McCune Ranch

PRELIMINARY PLAN

SP-18-006

COVER SHEET

SITE PLAN

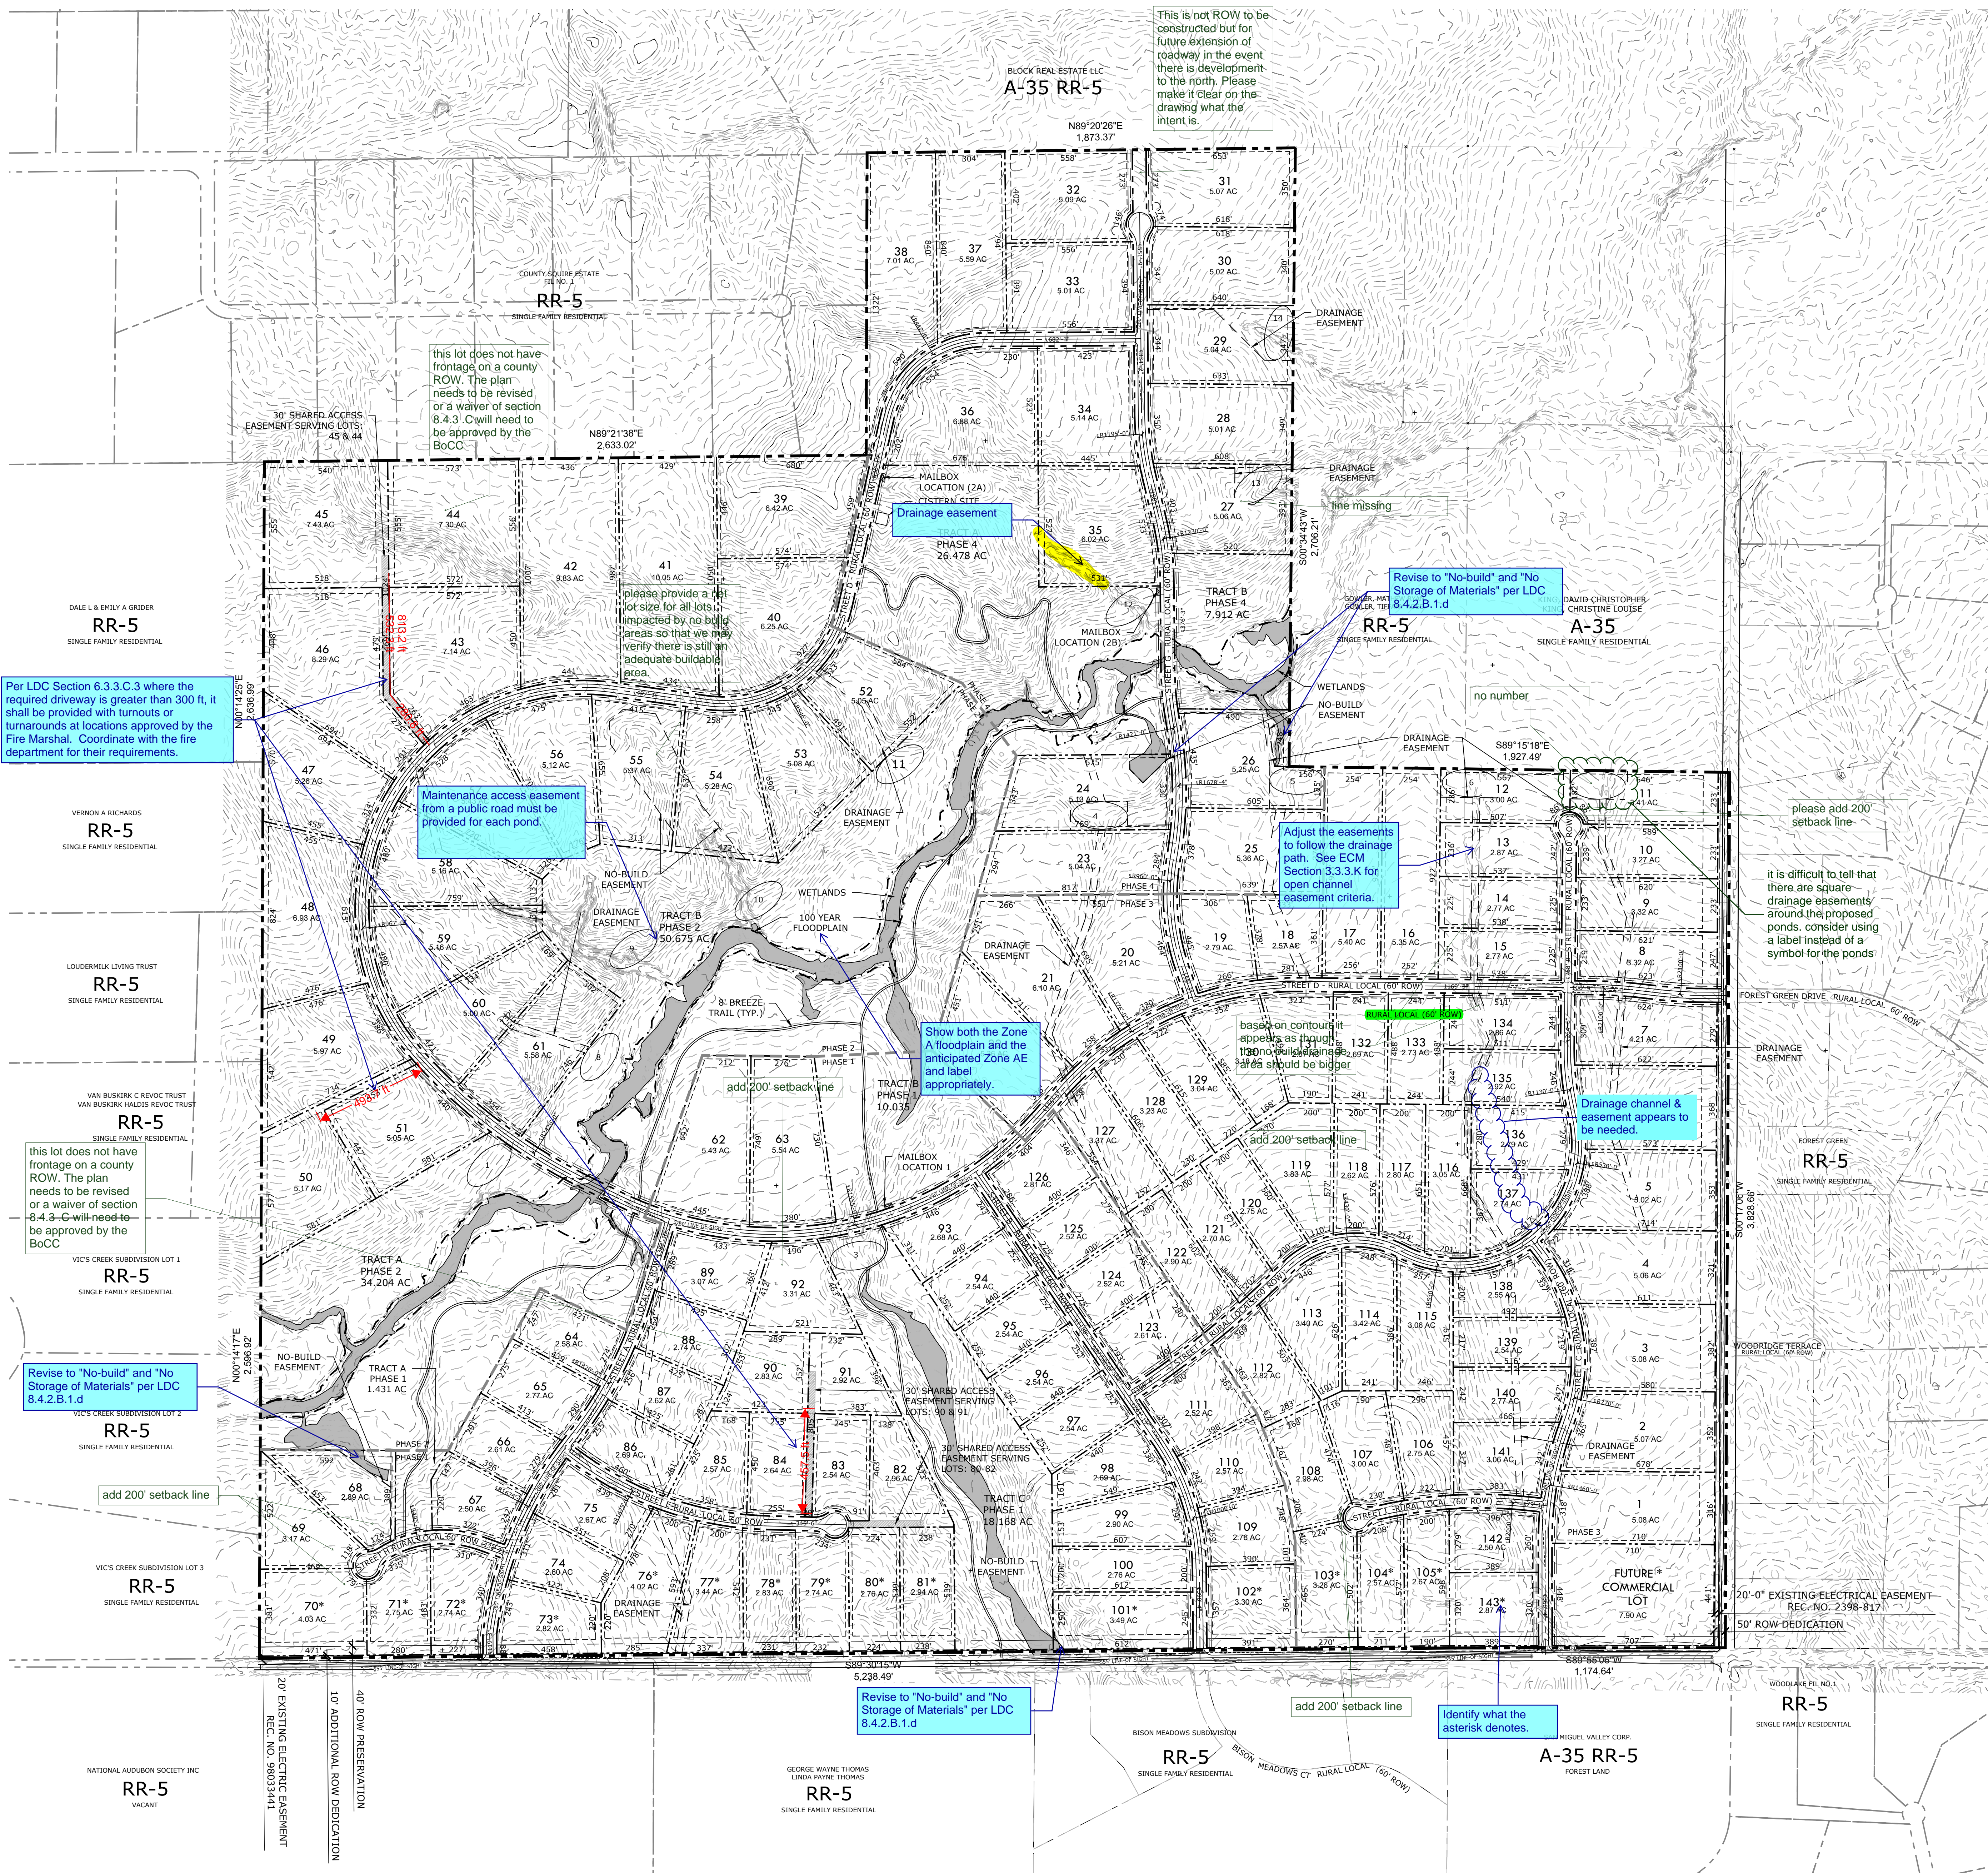
Revise to "No-build" and "No Storage of Materials" per LDC 8.4.2.B.1.d

Identify what the asterisk denotes.

Per LDC Section 6.3.3.C.3 where the required driveway is greater than 300 ft, it shall be provided with turnouts or turnarounds at locations approved by the Fire Marshal. Coordinate with the fire department for their requirements.

Adjust the easements to follow the drainage path. See ECM Section 3.3.3.K for open channel easement criteria.

Show both the Zone A floodplain and the anticipated Zone AE and label appropriately.

Drainage channel & easement appears to be needed.

Maintenance access easement from a public road must be provided for each pond.

The contours are not labeled with elevations to indicate the slope. Please add to one of the sheets or create a new sheet.

please add 200' setback line

it is difficult to tell that there are square drainage easements around the proposed ponds. consider using a label instead of a symbol for the ponds

This is not ROW to be constructed but for future extension of roadway in the event there is development to the north. Please make it clear on the drawing what the intent is.

this lot does not have frontage on a county ROW. The plan needs to be revised or a waiver of section 8.4.3 .C will need to be approved by the BoCC

please provide a net lot size for all lots impacted by no build areas so that we may verify there is still an adequate buildable area.

based on contours it appears as though the no build/drainage area should be bigger

HODGEN IMPROVEMENTS

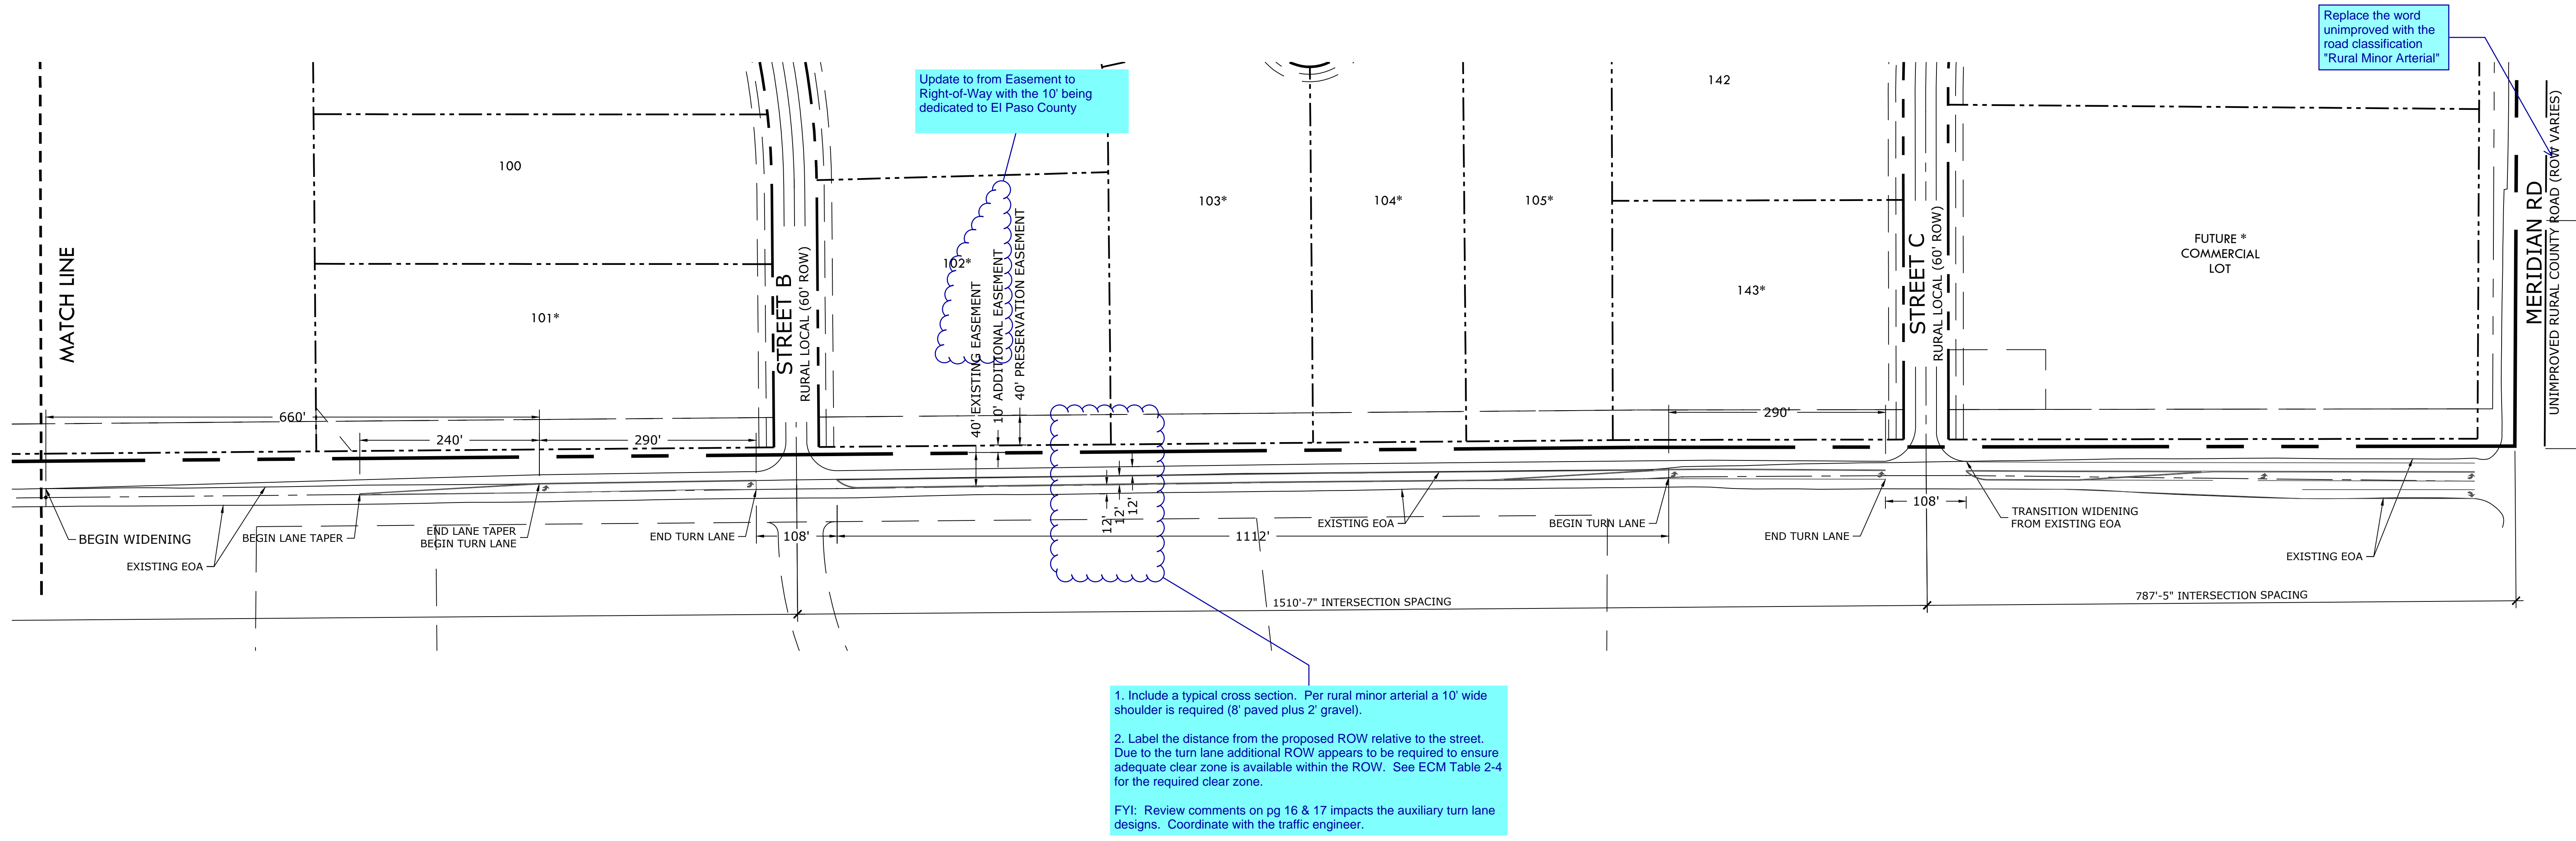
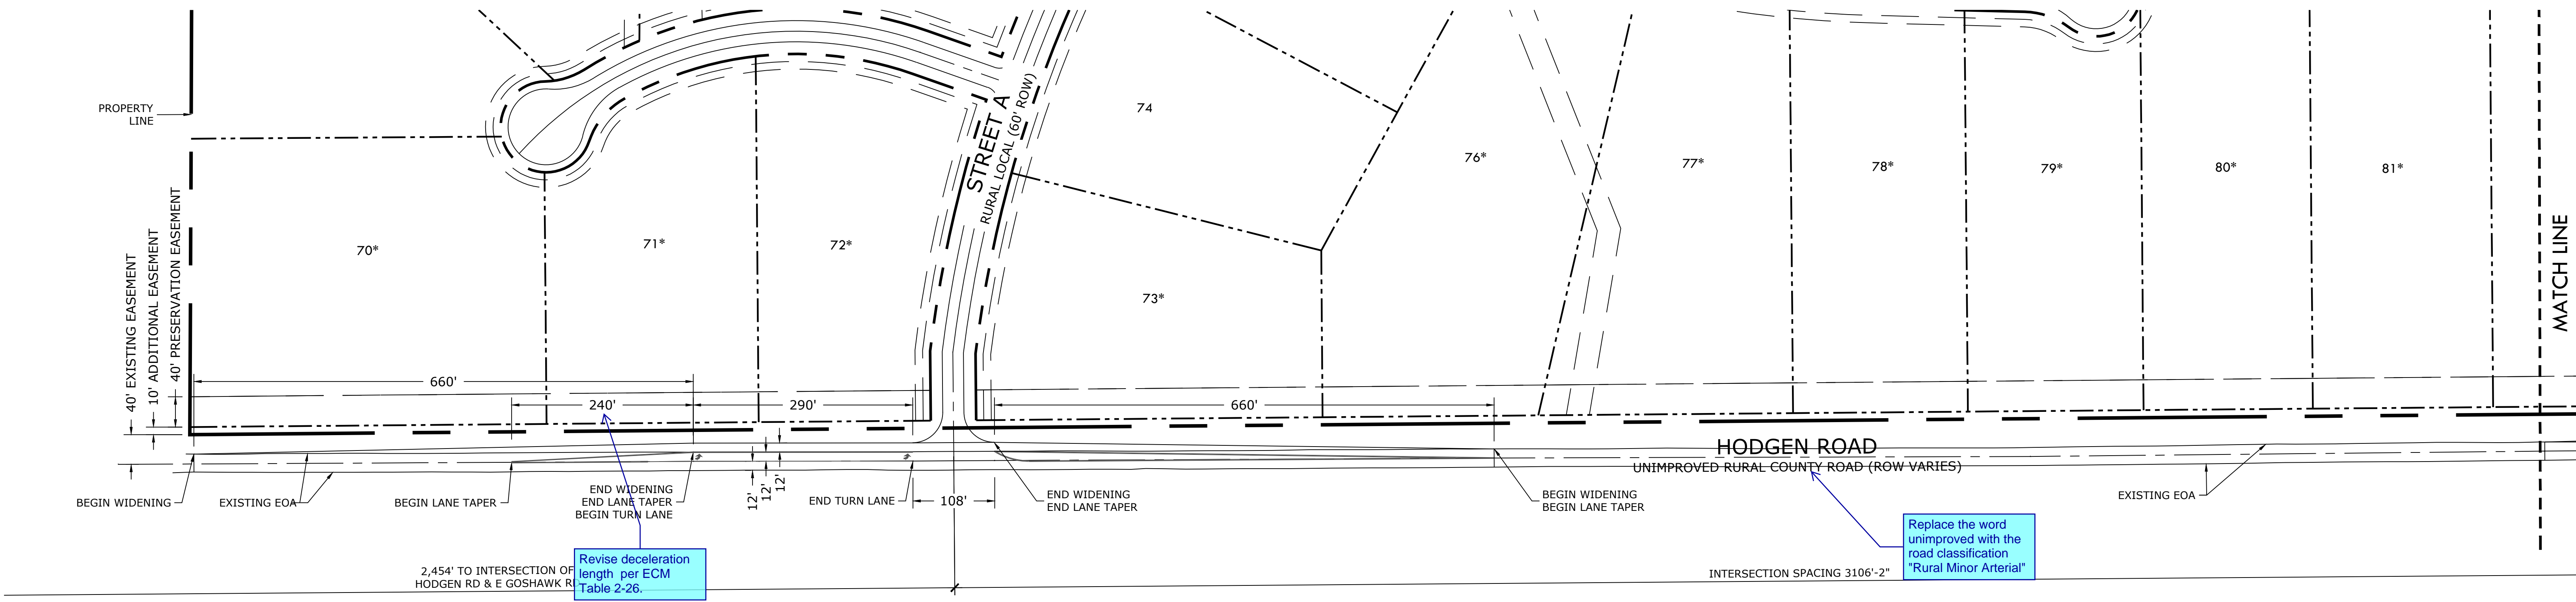
Update to from Easement to Right-of-Way with the 10' being dedicated to El Paso County

Replace the word unimproved with the road classification "Rural Minor Arterial"

Revise deceleration length per ECM Table 2-26.

1. Include a typical cross section. Per rural minor arterial a 10' wide shoulder is required (8' paved plus 2' gravel).

2. Label the distance from the proposed ROW relative to the street. Due to the turn lane additional ROW appears to be required to ensure adequate clear zone is available within the ROW. See ECM Table 2-4 for the required clear zone.
